Groundwater & Wastewater Services
Septic Project File & Data Review Worksheet

GWS File #: 783 B WASPS App #: 2035

MECKLENBURG COUNTY GROUNDWATER & WASTEWATER SERVICES
APPLICATION FOR A RESIDENTIAL SITE IMPROVEMENT PERMIT/ CONSTRUCTION AUTHORIZATION FOR AN ON-SITE WASTEWATER SYSTEM, NEW WELL INSTALLATION, OR REPAIR OF EXISTING WELL

SOIL/SITE EVALUATION
for ON-SITE WASTEWATER SYSTEM

PROPOSED PLOT PLAN

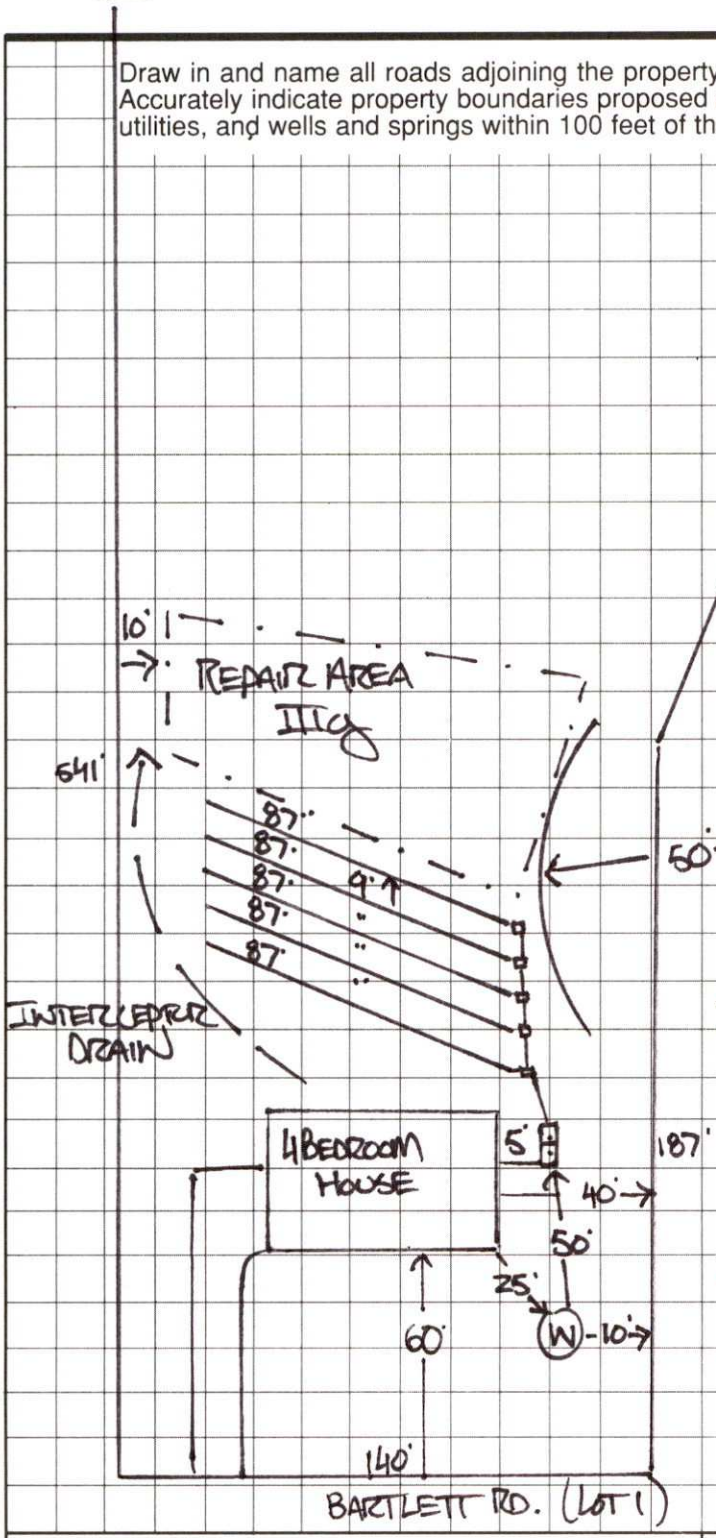
show well

show bed chamber

Sketch of Soil Evaluation Locations

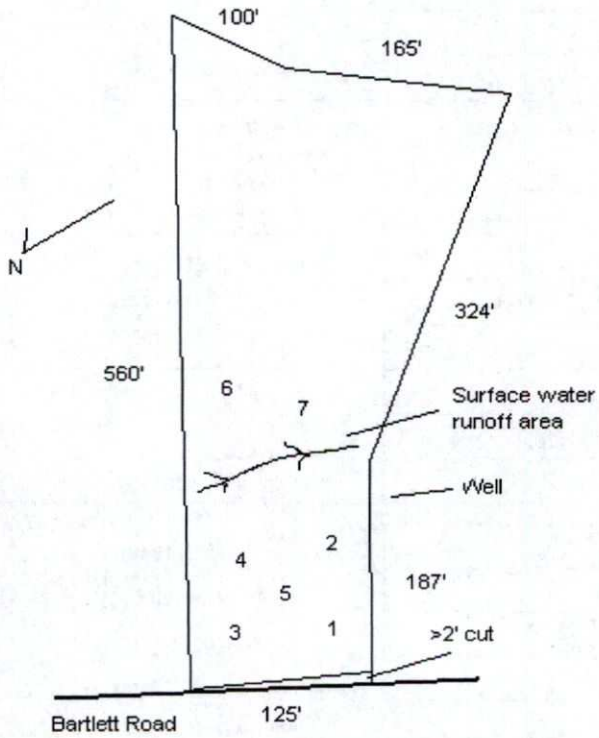
100% repair, consider subsurface interceptor drain if lines are installed in areas of profiles 6 & 7

Sketch of Soil Evaluation Locations

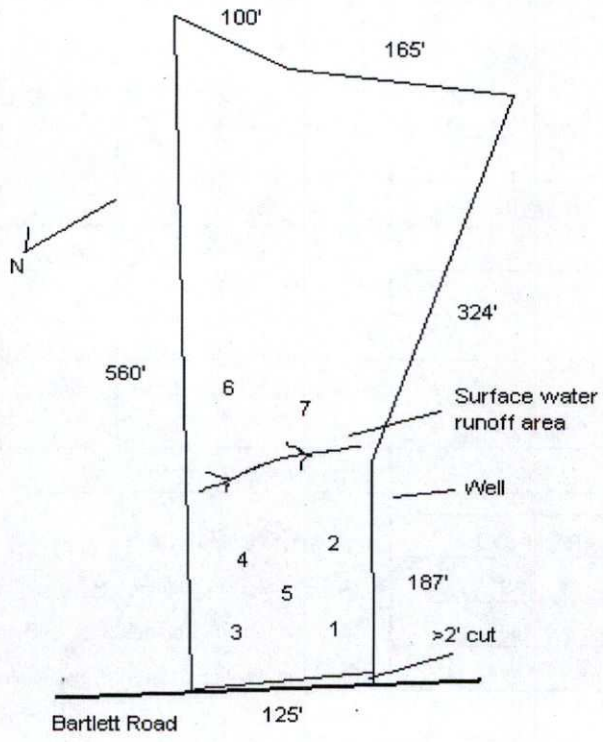
100% repair, consider subsurface interceptor drain if lines are installed in areas of profiles 6 & 7
